Important Safety Notice

HDE/ Greenlee RT-10 Rope Tester & CT-300 ClearTest® Transformer Tester That Use Two Batteries

March 9, 2022

Figure 6 - Unit carton Label includes marking “Uses one 9V Lithium battery (included).” Not subject to safety notice

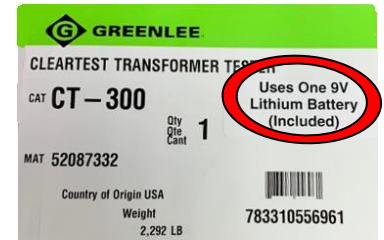
If the Tester has been reworked by Greenlee / HDE to remove contacts in one of the 9V battery compartments (as shown in figure 4) or has a single battery compartment (as shown in figure 5) the tester unit is not affected and is not subject to this Safety Notice. If the unit is in its original carton, and the carton label has the words “Uses one 9V Lithium battery (included)” on the label (see figure 6), the tester unit inside the carton is not affected and is not subject to this Safety Notice.
